Access Compliance Report

Public Rights-of-Way

(Curb Ramps)

Intersection ID: 30285	Main Street: DERRYFIELD_DR	Cross Street: HAMPTON_WAY_DR	Location: SE
ADA ID: CF12445956CC	Ramp Type: BlendTrans1	Initial Pass/Fail: Fail	Overall Compliance: No
Severity Score: 8.75			
Codes/Mitigation Info/Possible Solution		Field Measurements/Component Compliance

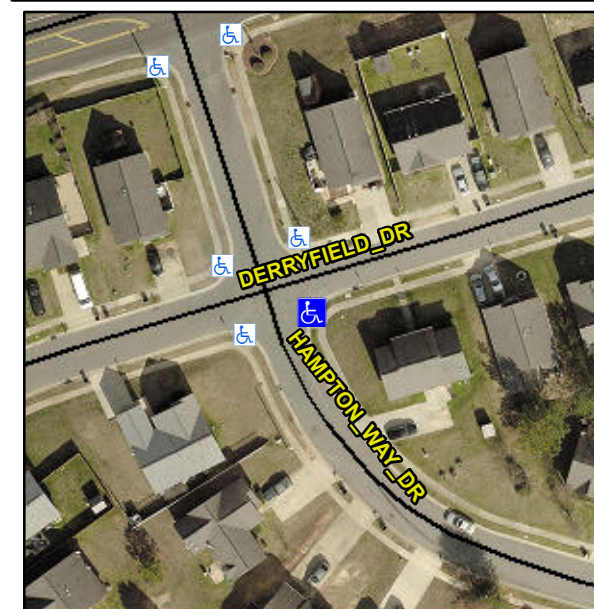
Not Found, R304.5.1

Compliance	Description	Data	Compliance	Description	Data
N/A	Ramp Length (in)	47.5	Yes	BlendTrans Slope (%)	3.8
No	Ramp Width (in)	37.0	Yes	BlendTrans XSlope (%)	2.0
N/A	Flare Type LT	N/A	N/A	Flare Type RT	N/A
N/A	Flare Slope LT (%)	N/A	N/A	Flare Slope RT (%)	N/A
N/A	Flare Traversable LT?	N/A	N/A	Flare Traversable RT?	N/A
N/A	Landing Length (in)	N/A	N/A	DWS Provided?	N/A
N/A	Landing Width (in)	N/A	N/A	DWS Contrast?	N/A
N/A	Landing Slope (%)	N/A	N/A	DWS Length (in)	N/A
N/A	Landing X Slope (%)	N/A	N/A	DWS Full Width?	N/A
N/A	Landing Curb? (Y/N)	N/A	N/A	DWS Offset (in)	N/A
N/A	Shared Landing?	N/A			
N/A	Gutter Ponding?	N/A	N/A	Gutter Slope (%)	N/A
N/A	Gutter Lip Ht (in)	N/A	N/A	Gutter X Slope (%)	N/A
N/A	Painted X Walk1?	No	N/A	Painted X Walk2?	No
	X Walk 1 Direction	To N		X Walk 2 Direction	To SW
	X Walk 1 Width (in)	N/A		X Walk 2 Width (in)	N/A
	X Walk 1 Slope (%)	2.6		X Walk 2 Slope (%)	0.4
	X Walk 1 X Slope (%)	1.9		X Walk 2 X Slope (%)	5.4

N/A	Ramp inside XWalk1?	N/A	N/A	Ramp inside XWalk2?	N/A
	Road Slope (%)	3.7		Clear Space?	N/A
	Road X Slope (%)	1.5	N/A	Clear Space to XWalk (in)	N/A
N/A	Any Obstructions?	N/A	N/A	Storm Grate/Utility Hazard?	N/A
	Obstruction Type			Storm Grate/Utility Type	
		N/A			N/A
			Yes	Surface Condition? (G/P)	Good
			No	Curb Slope (%)	23.0

Remove & Replace Curb Ramp With Two New Directional Ramps or Equivalent.
